# SUPPLEMENTARY ASSESSMENT REPORT

## BAYSIDE COUNCIL

<b>Application Number:</b>	DA-2021/95 PPSEC-130
<b>Date of Receipt:</b>	15 March 2021
<b>Property:</b>	119 Barton Street, Monterey
<b>Lot &amp; DP/SP No:</b>	Lot 2 DP 857520
<b>Owner:</b>	Monterey Equity Pty Ltd
<b>Applicant:</b>	Monterey Equity Pty Ltd
<b>Proposal:</b>	Integrated Development - Demolition of existing structures and construction of a part 2 and part 3 storey residential aged care facility comprising of 113 rooms (116 beds), basement level parking, front fencing and signage
<b>Value:</b>	\$36,365,251.00
<b>Author:</b>	Michael Maloof – Senior Assessment Planner  Pascal van de Walle – Coordinator Development Assessment
<b>Date of Report:</b>	8 December 2021
<b>No. of submissions:</b>	12 individual submissions and 1 petition
<b>Recommendation:</b>	REFUSAL

**Figure 11** - Extent of building above 8m to the underside of the ceiling (as measured by Seniors Living SEPP). The proposal includes a roof above which is not shown in the plan above but which extends up to 12.6m in height.

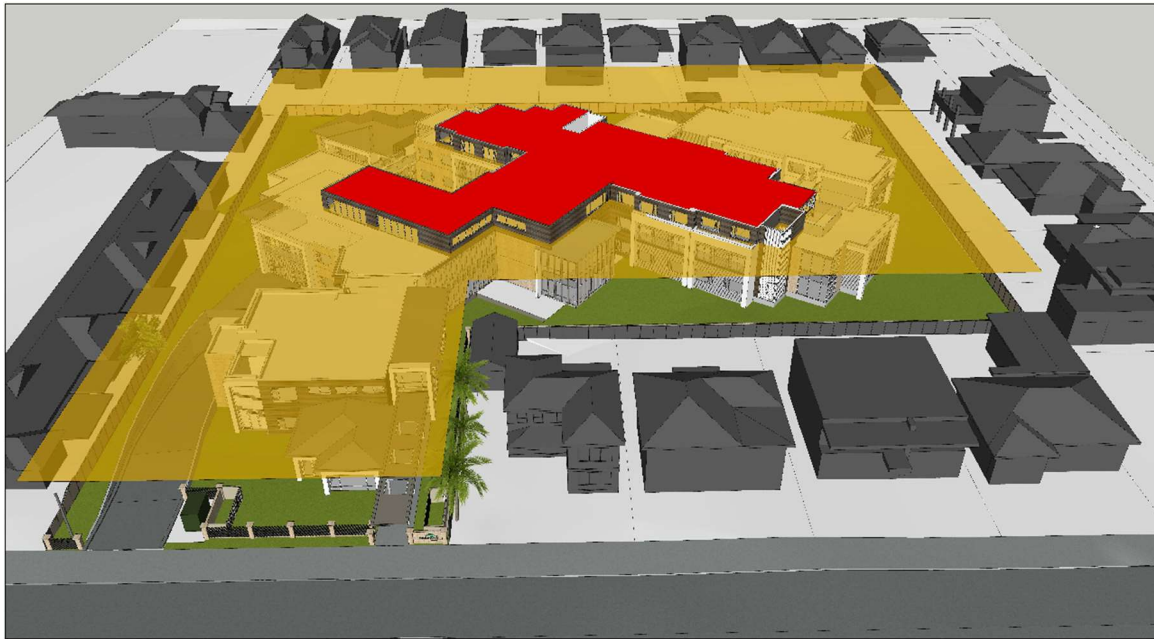
As discussed in detail on pages 24-26 of the original Planning Assessment Report, Council are of the view that the building is three (3) storey adjacent to the sites boundary however the Applicant now considers that there may be some uncertainty around whether parts of the third storey are 'adjacent' to the boundary and therefore, for completeness, have submitted an a Clause 4.6 variation request that responds to both Clauses 40(4)(a) and 40(4)(b).

The three (3) storey built form is located only 6.17m from No. 109 Barton St, only 7.5m from 111 Barton Street and 8m from No. 115 Barton Street (with the Activity deck only 5.2m from the boundary with No. 115). The third floor is also 19.5m from the sites southern boundary, 21.2m from the sites western boundary and 15.4m from the sites eastern boundary.

The site and adjoining properties are zoned R3 Medium Density Housing. Developments are restricted to a maximum of 8.5m and 2 storey in height. The proposed three (3) storey built form is located a minimum of approximately 6m from No.109 Barton Street and No. 115 Barton Street, and nearby No.111 Barton Street. As shown in Figures 2 & 6 it is evident that the proposed three storey portion of the development is of an inappropriate scale that will result in adverse visual bulk to neighbouring properties, particularly when viewed from within rear yards of adjoining properties to the north and west. Figure 3 shows that the proposed two storey built form is inappropriate for the existing and desired 8.5m / 2 storey building height context of surrounding sites.

The applicant's rationale is not agreed with and the proposal is considered to be contrary to the underlying objectives of Clause 40. Specifically,

- The proposal will not provide an appropriate transition in built form and land use intensity.
- The proposed building height does not encourage high quality urban form.
- The proposed building height will have adverse impacts on the sky exposure enjoyed by surrounding residents, particularly those to the north

**Figure 12** - Setbacks for 3rd Floor of proposal to the rear of properties fronting Barton Street

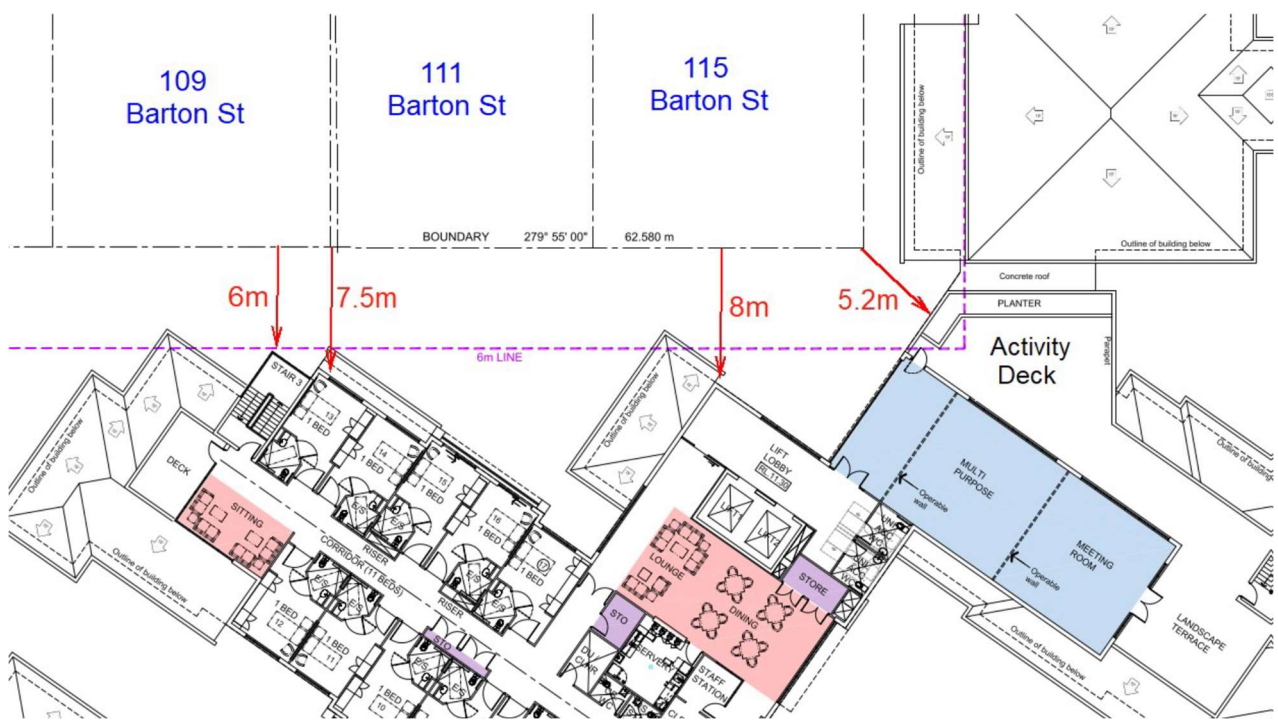
**Height:** Building rotation and privacy screens alone are not sufficient to resolve the massing and bulk impacts and the upper most floor should be setback further from the properties to the north fronting Barton Street.
